PLANNING DEPARTMENT  
Staff Report & Recommendation

Design Review Board

SUBJECT: DRB19-0494  
**5800 Pine Tree Drive**

An application has been filed requesting Design Review Approval for the construction of a second floor addition to an existing two-story pre-1942 architecturally significant single-family residence, including a variance to reduce the required rear setback.

Sheet A2.0 "WEST" Elevation

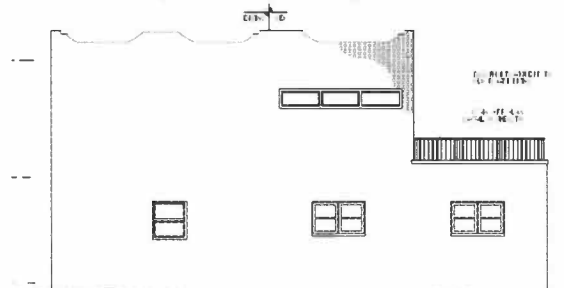
Staff would recommend that the architect modify the fenestration in the ribbon windows for the new addition along the east elevation (Sheet A2.0) to be located at a slightly higher elevation in order to facilitate light into the proposed new room and ensure that the new addition will not decrease the privacy of the abutting property to the west.

Additionally, staff would recommend raising the bottom window sill height to prevent the direct gaze of an average sized person (5'-8") through the window, or frosting the glass. With this minor modification, staff recommends approval of the design.

- a. The architect shall revise the ribbon window location on Sheet A2.0 to be located at a slightly higher elevation in order to facilitate light into the proposed new room but ensure that the new addition will not decrease the privacy of the abutting property to the west, at a minimum raising the bottom

sill window height to prevent the direct gaze of an average sized person (5'-8") through the window, or frosting the glass.
